STAFF REPORT 5-8-2019 MEETING  
APPLICATION NUMBER 19-6181  
ADDRESS: 2081 VERMONT  
HISTORIC DISTRICT: CORKTOWN  
APPLICANT: JIM KORF  
DATE OF STAFF VISIT: 5-2-2019

Re: Building Rehabilitation  
2081 Vermont  
Detroit, Michigan

A3.2

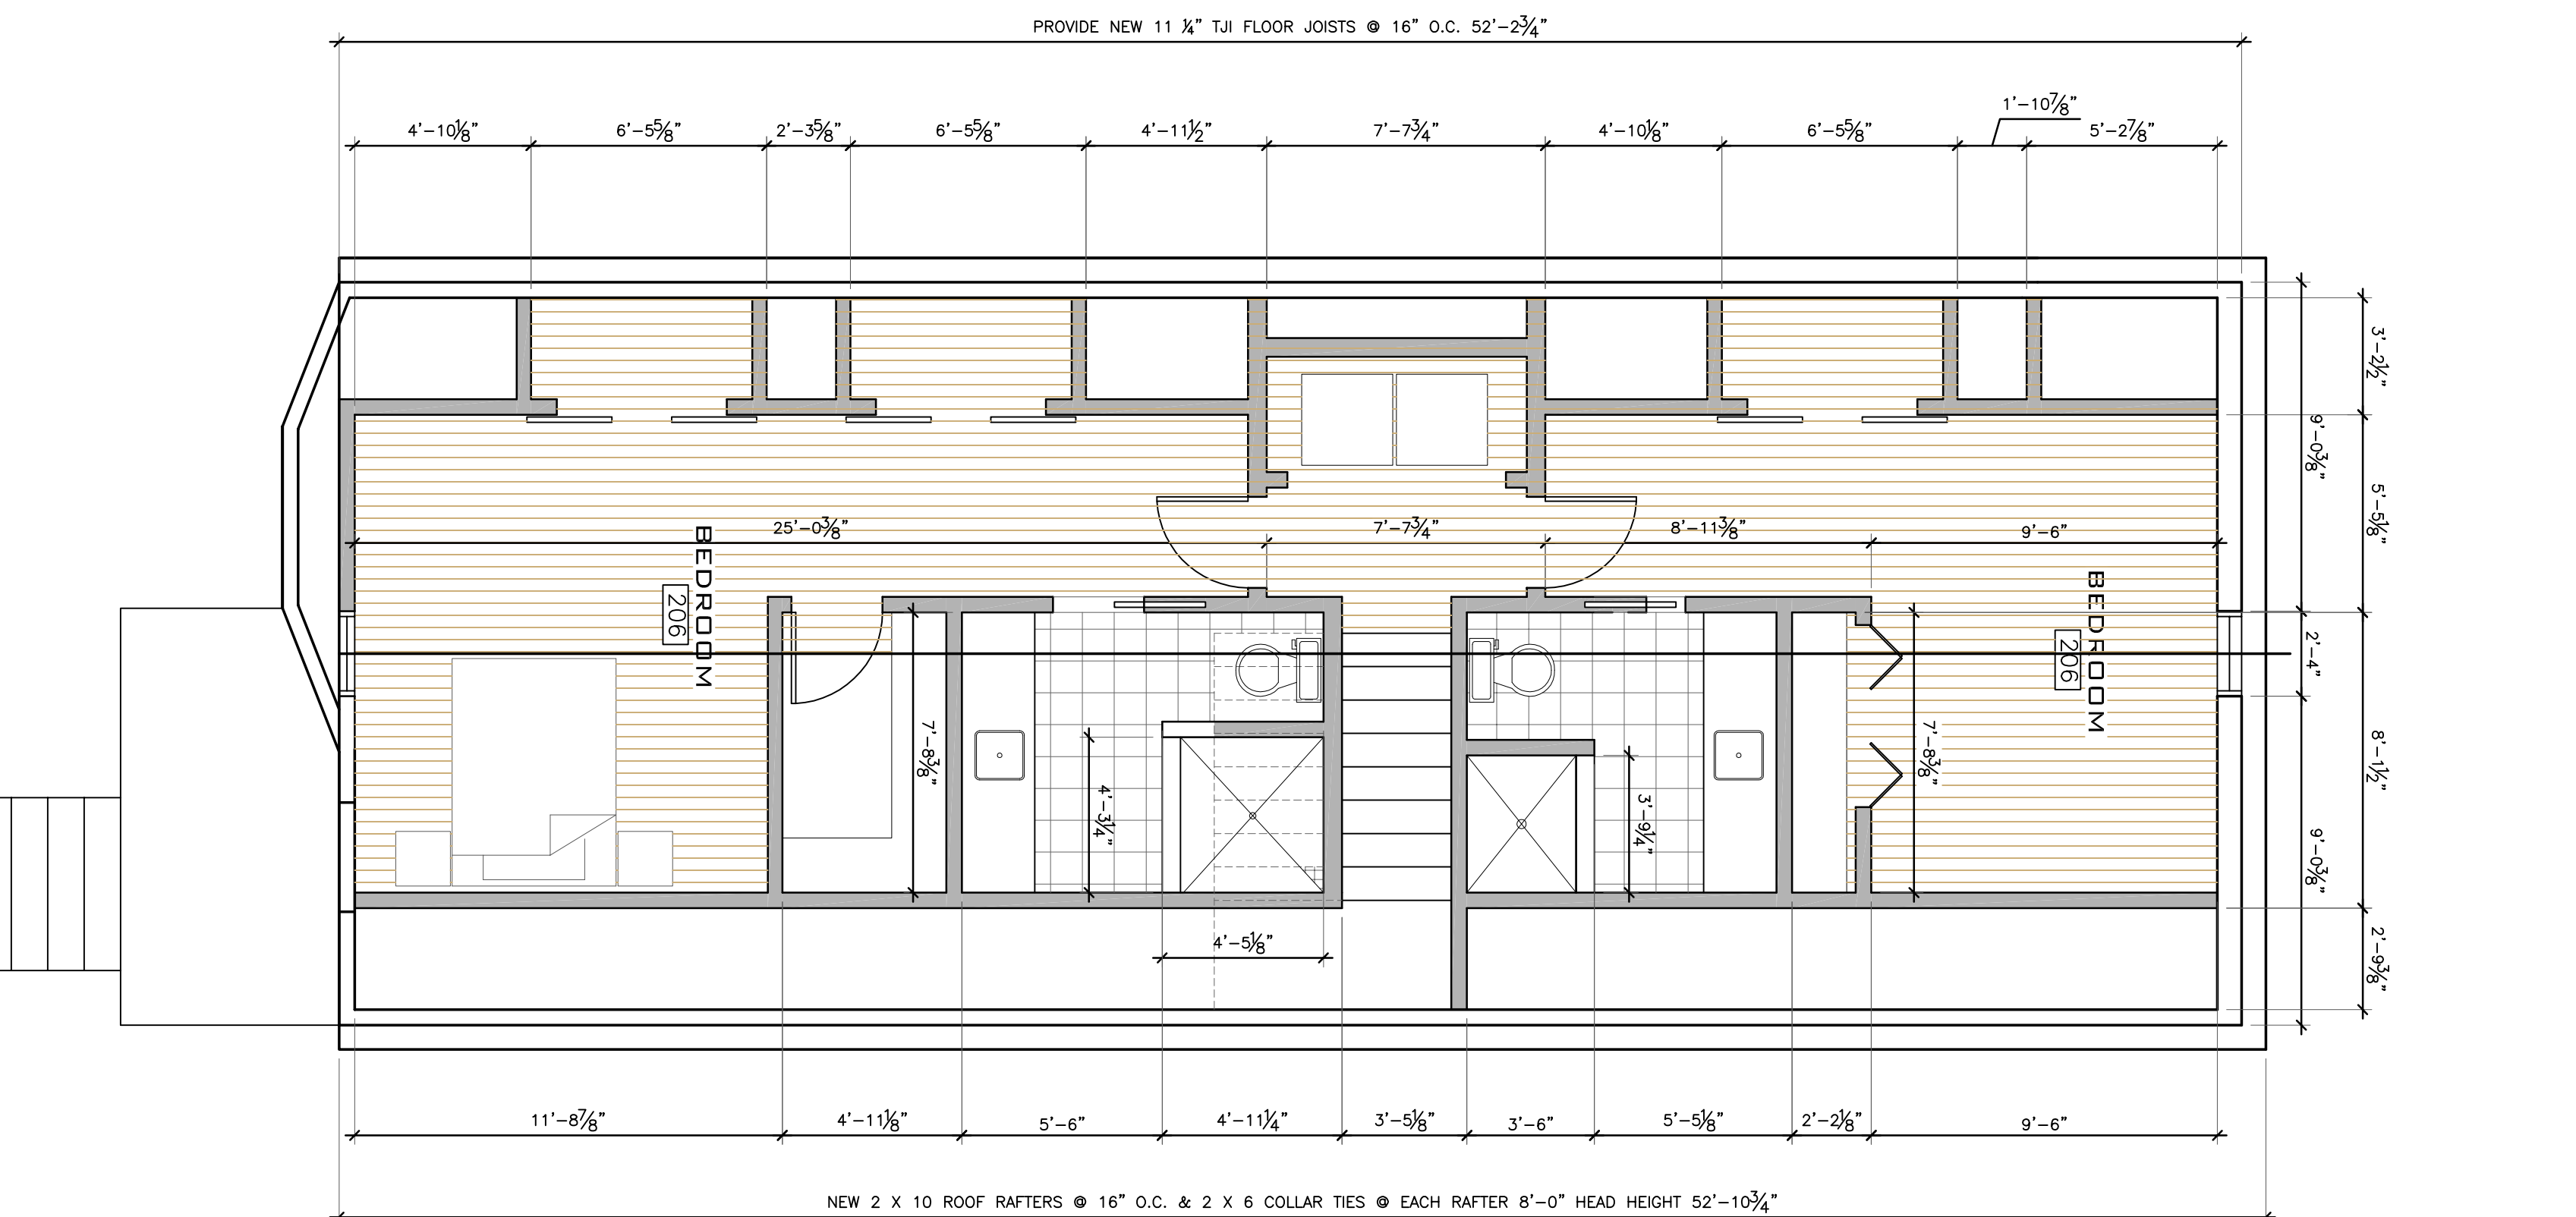
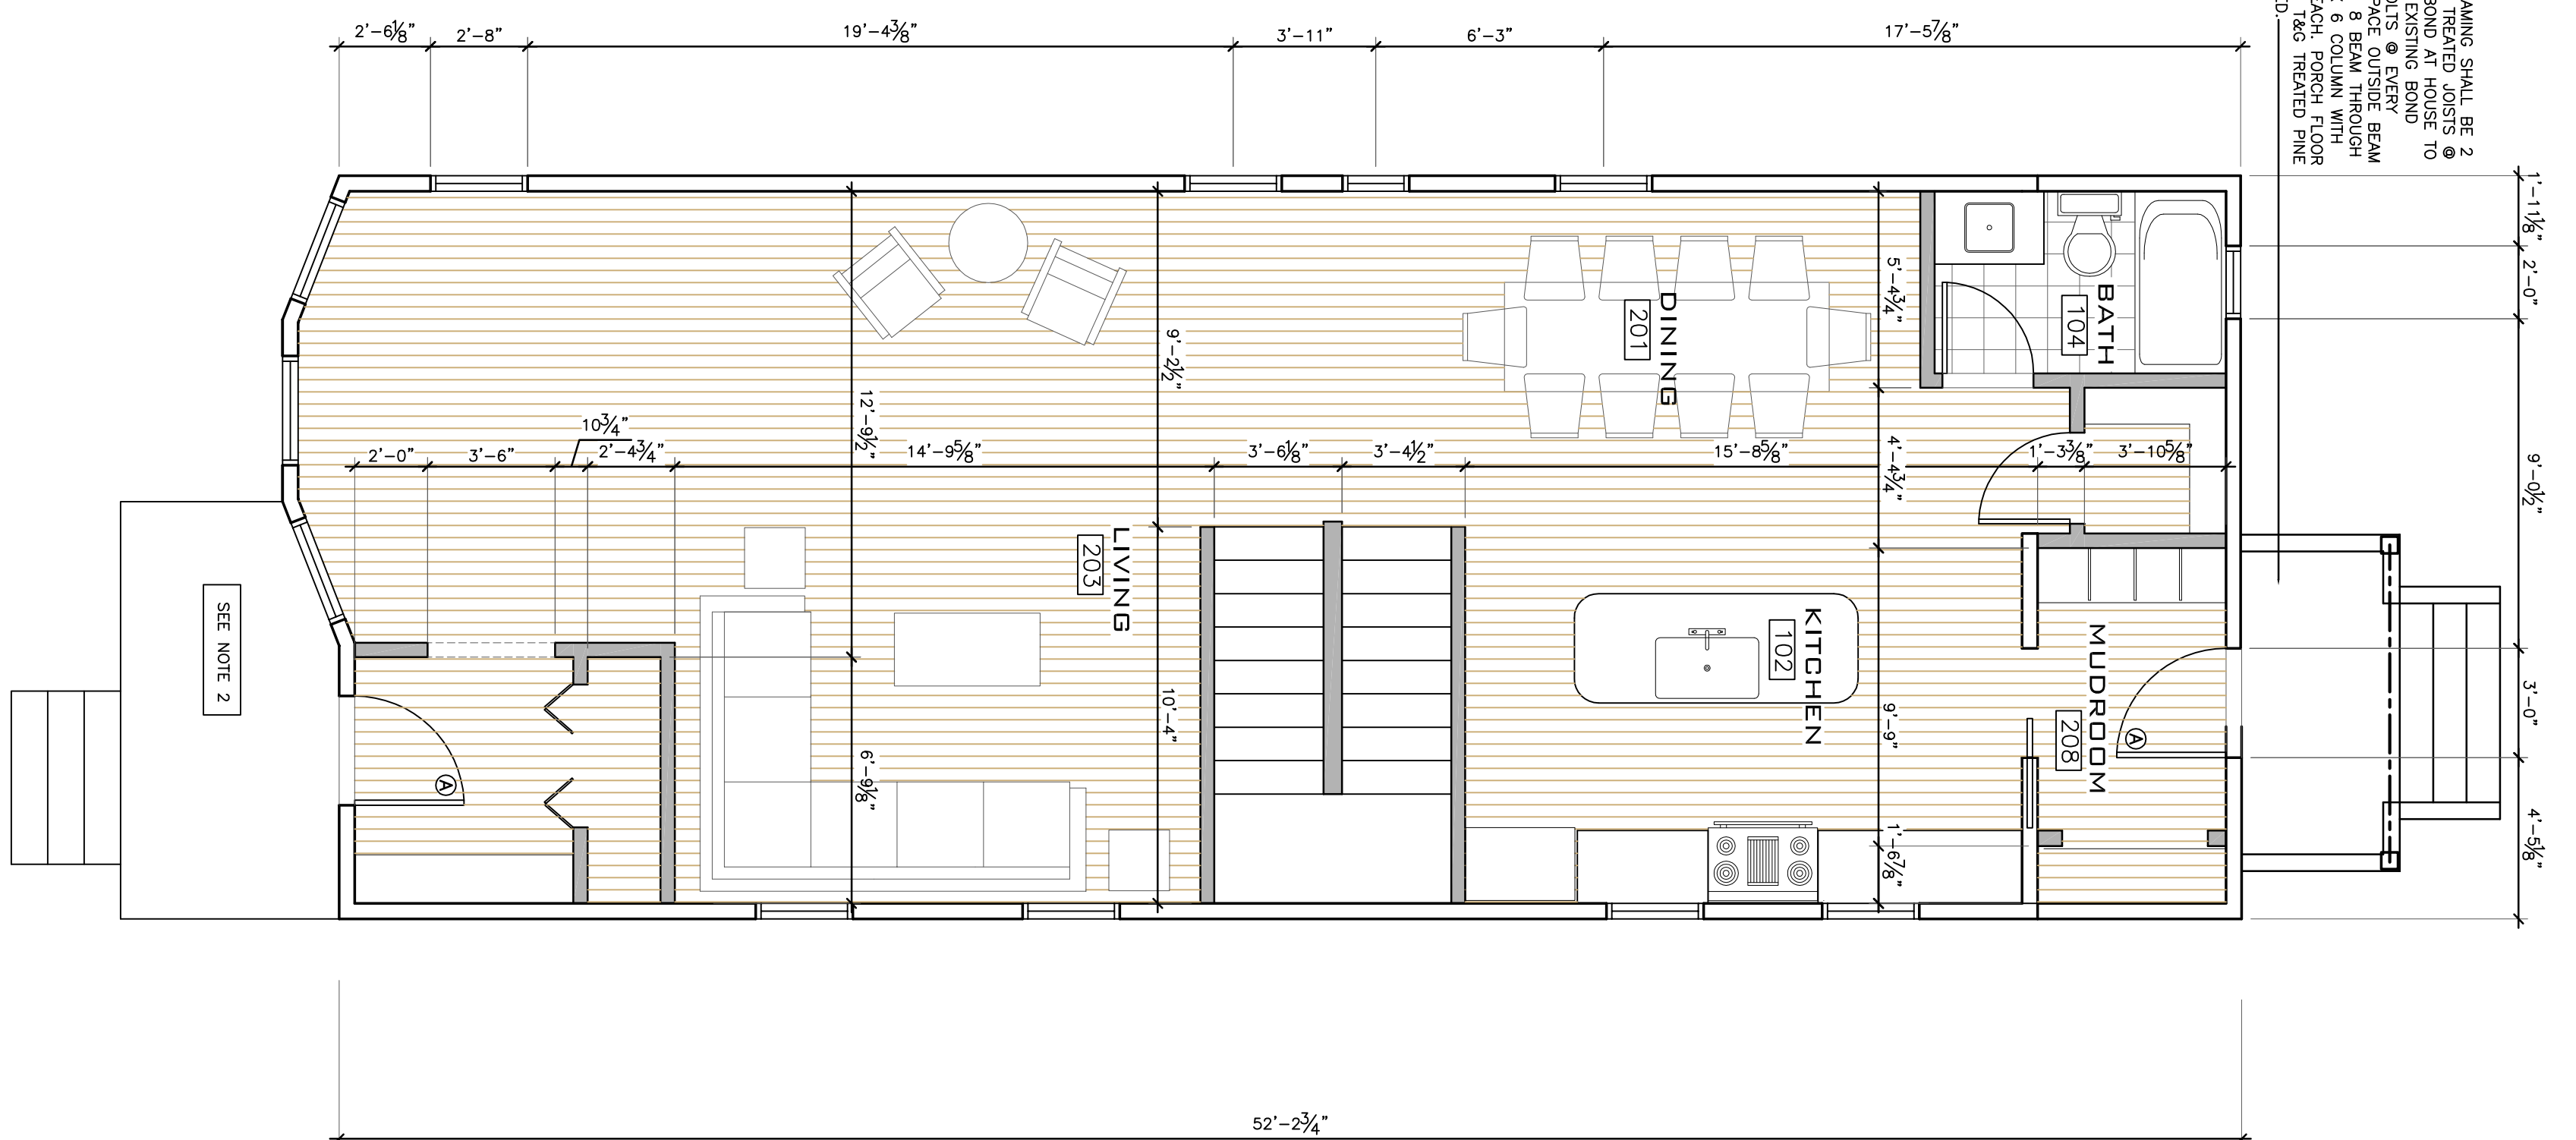
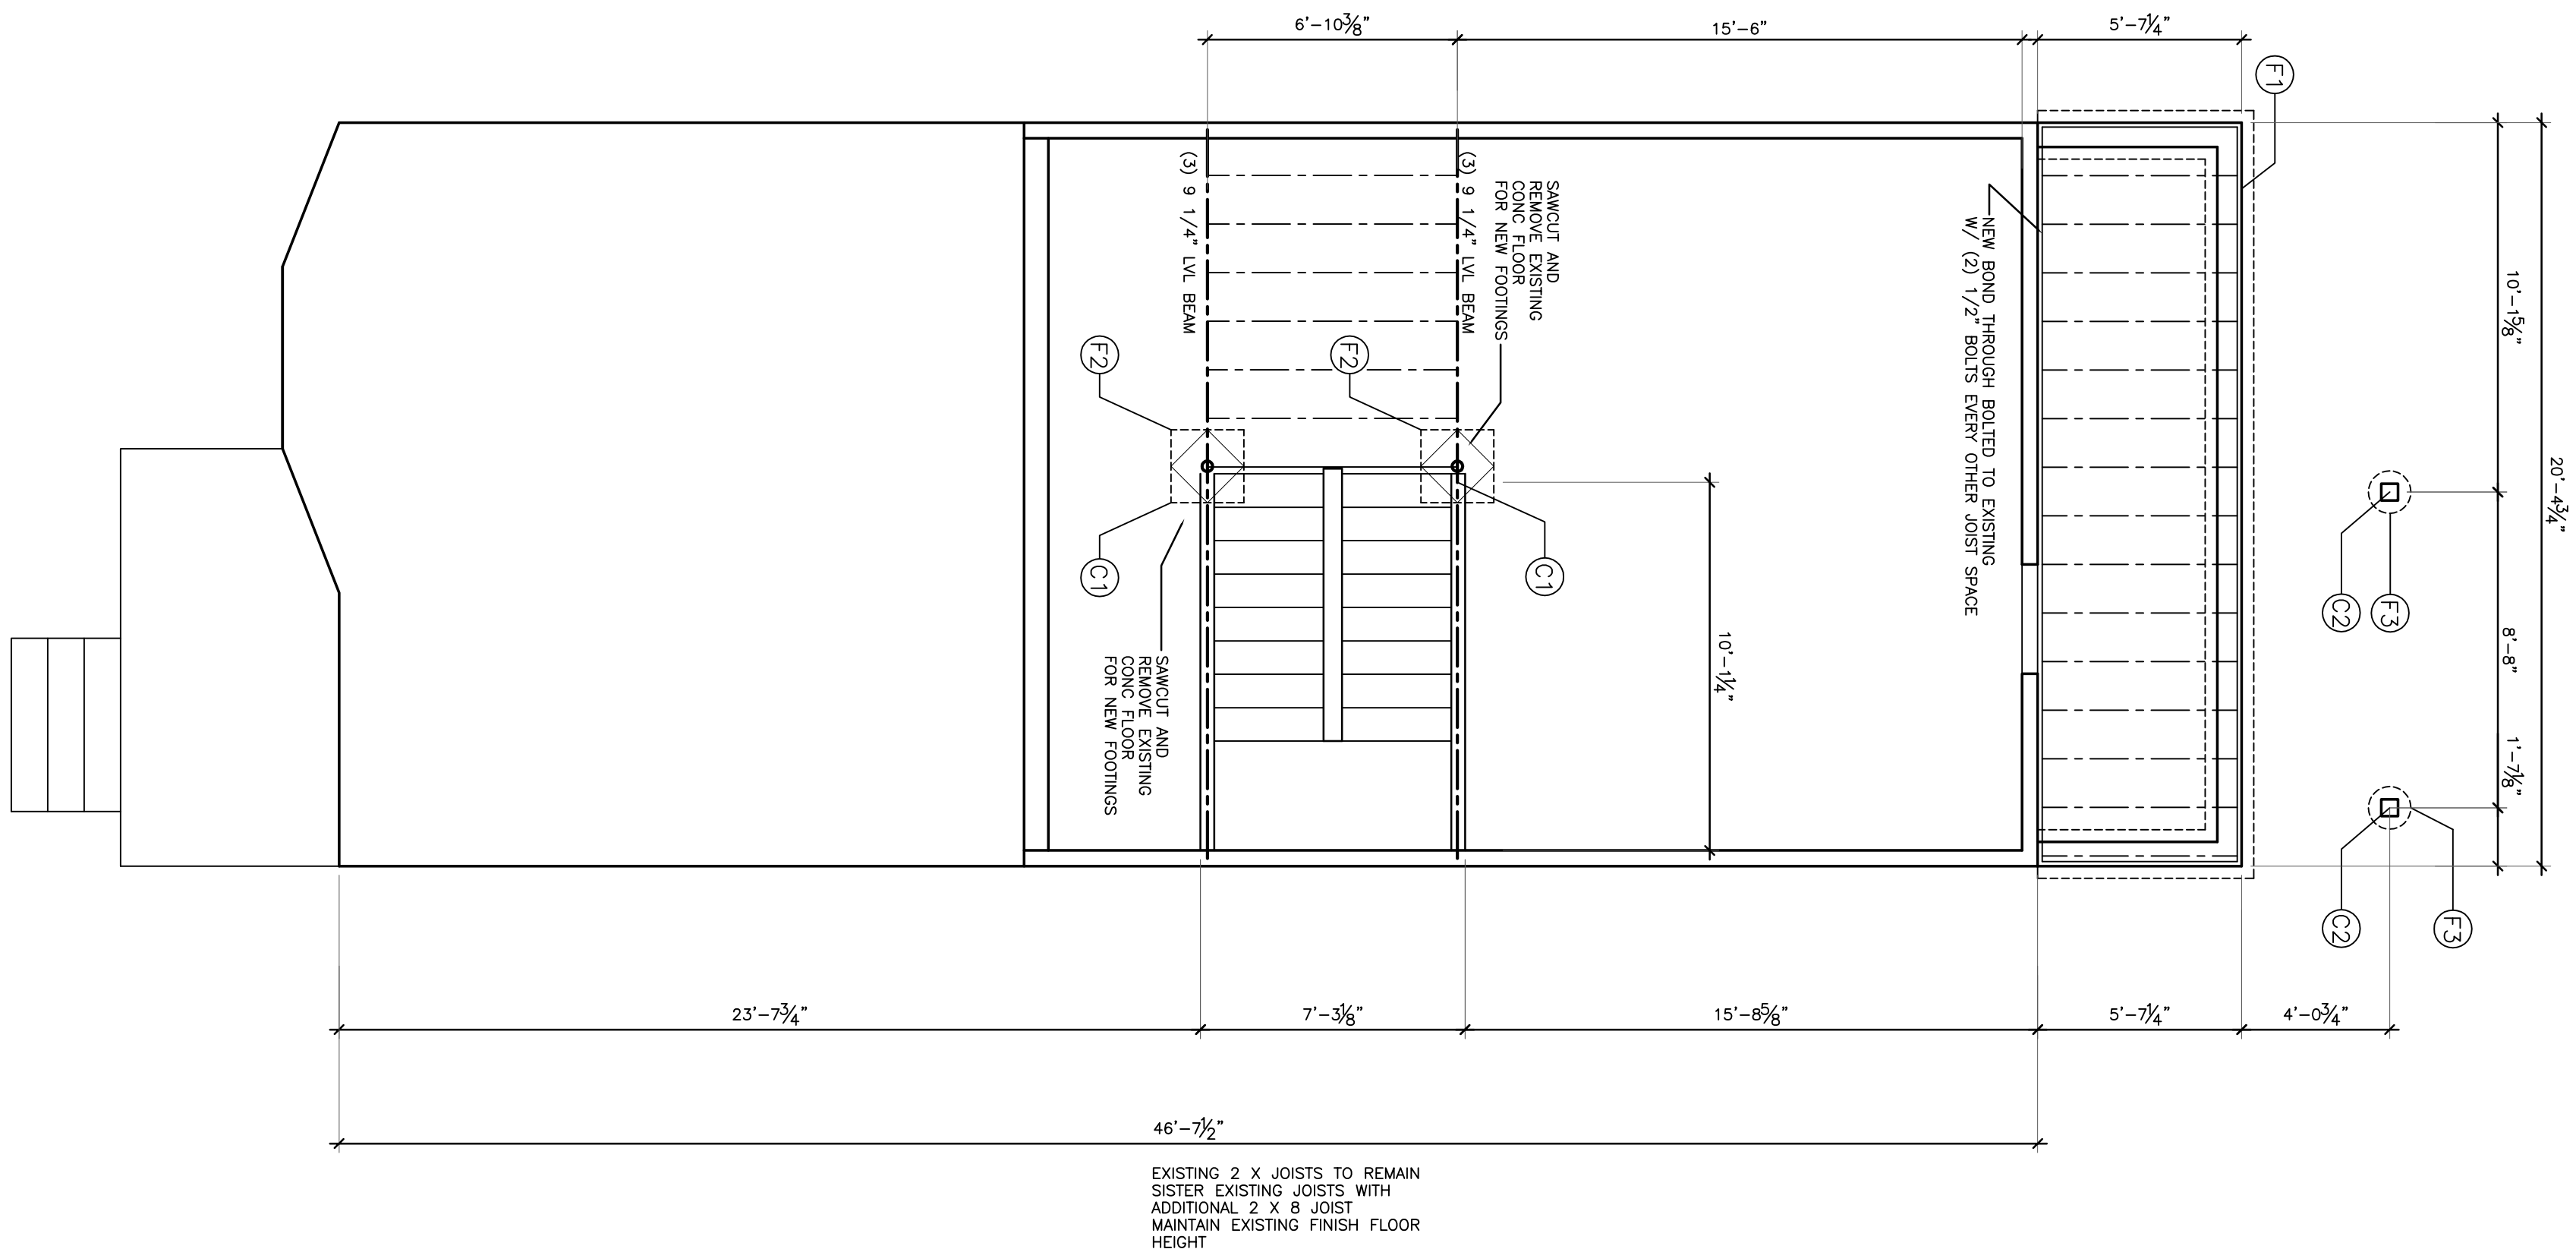
- The existing front porch roof is flat. The proposed/new front porch roof is hipped
- New wood skirting is proposed to clad the brick at the rear ½ portion of the side elevation foundation walls and the rear foundation will
- The brick chimney is proposed to be removed
- The existing original 2/2 wood windows at the side elevations are proposed to be replaced with new 1/1 wood windows
-

It appears that the roof will be raised as the new windows proposed for the front and rear gable ends are larger than the current windows. However, this work item is unclear as the current application does not provide height dimensions and pitch for the existing vs the proposed. Staff did pose this question to the applicant, but has not received an answer as of the date of this report's completion.

- The new front porch roof shall be flat/shed to replicate the existing
- The existing wood siding, corner trim, and window trim/brickmould at the front and side elevations shall be retained and repaired where necessary with new to match the existing in material, dimension, reveal, and detailing
- The new wood sash at the front and side elevations shall match the existing/those proposed for replacement in light configuration and operation
- The existing brick chimney must be retained or replicated (if replacement is necessary)
- The existing roof height and pitch shall be maintained
